**EB-2022-0200**  
**Enbridge Gas 2024-2028 Rates**

**Interrogatories of Environmental Defence – Part 2**

**Exhibit 3-5 New England Natural Gas Demand by Sector**

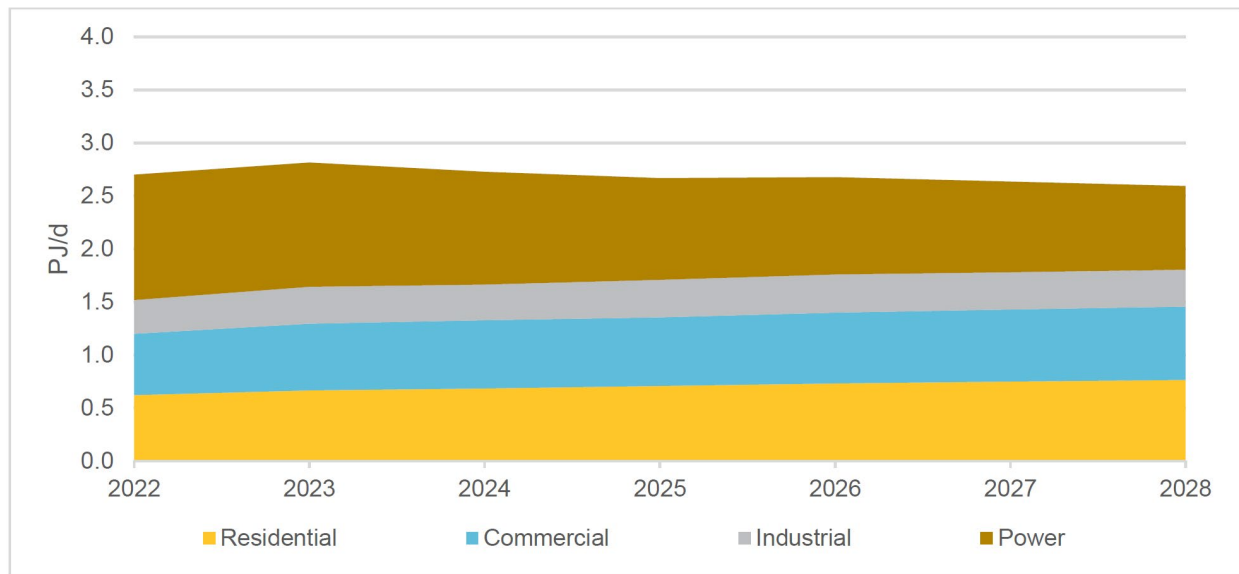
- (a) In forecasting the contract demand on the Dawn Parkway system, did ICF consider the ISO New England Final 2022 Heating Electrification Forecast ([link](#))? Did ICF consider Vermont's GHG emissions reductions legislation? Did ICF consider New York's decarbonization pathways study?
- (b) If not, please do so.
- (c) Please provide a breakdown of the forecast Ontario demand by summer and winter.

**Exhibit 3-13 ICF Q2 2022 Dawn Parkway Winter Utilization (%)**

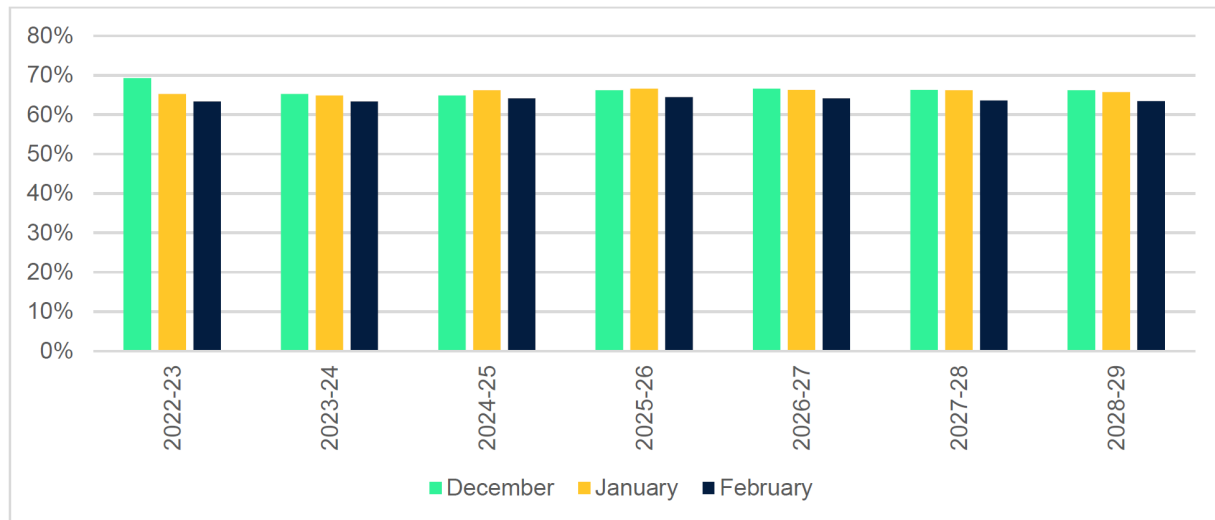
- (a) Please provide six versions of the above figure – one for each of the customer types listed in exhibit 2-2 on page 6. Alternatively, if it is easier, please provide the same information but in table format.

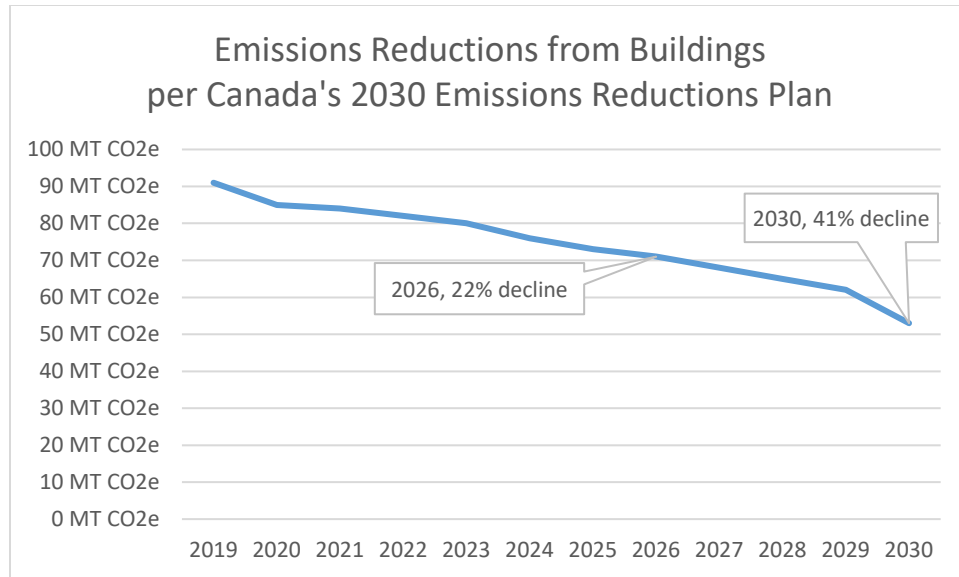
- What is the approximate probability that the incremental pipeline capacity is only needed until (i) 2035, (ii) 2040, and (iii) 2050?
- Canada's 2030 Emissions Reduction Plan includes targets for carbon emissions from buildings to decline by 22% by 2026 and by 41% by 2030 (illustrated below).<sup>64</sup> This is based on a reduction from 91 CO<sub>2</sub>e in 2019 to 71 CO<sub>2</sub>e in 2026 and 53 CO<sub>2</sub>e in 2030.

How might this impact the demand for the incremental capacity from this project before the end of its economic lifetime? Please provide a quantitative answer on a best-efforts basis, stating any necessary caveats and assumptions, and providing a range of possible impacts if appropriate.
